## Product Change Notification: MAAN-25PKAF930

CCB 7196.016 Final Notice: Qualification of MTAI as a new final test site for selected ATTINY261A, AT89S2051, AT89LP2052, AT89LP4052, AT89C2051, ATTINY2313, AT89C4051, ATTINY861A, ATTINY2313A, ATTINY26 and ATTINY4313 device families available in 20L PDIP (.300in) package.

**CCB 7196.016**  
**Pre and Post Change Summary**  
**PCN #: MAAN-25PKAF930**

# Pre and Post Change Summary - TUBE

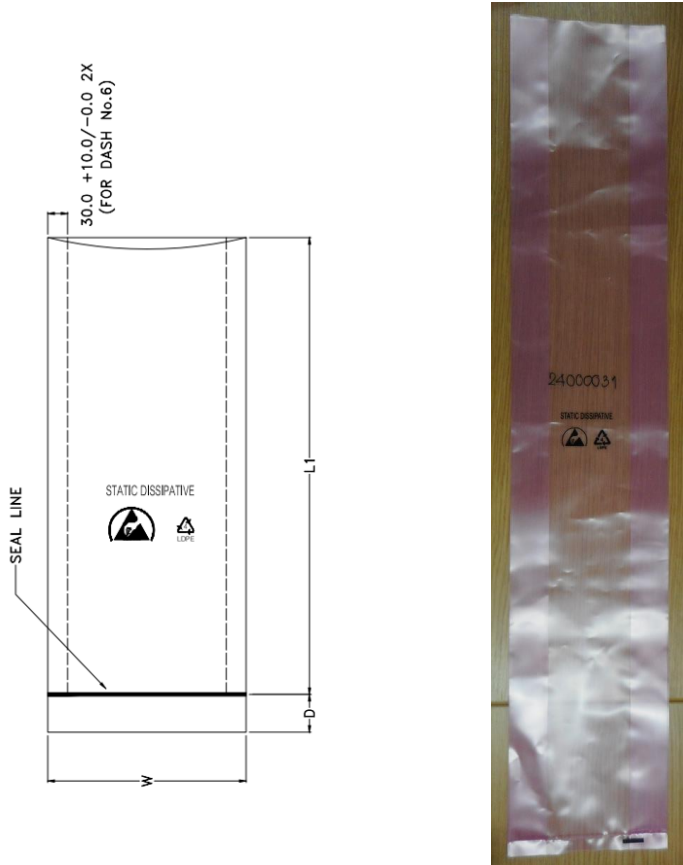
Location	Tube Length (inch)	Dimension	Tube Length between Hole Usage	Unit per Tube	Tube per Bag	Tube Color
MPHL	20.33 +/- 0.030	See on drawing	19.53 +/- 0.030	18	40	Transparent Clear
MTAI	20.33 +/- 0.030	See on drawing	19.53 +/- 0.030	18	40	Transparent Clear
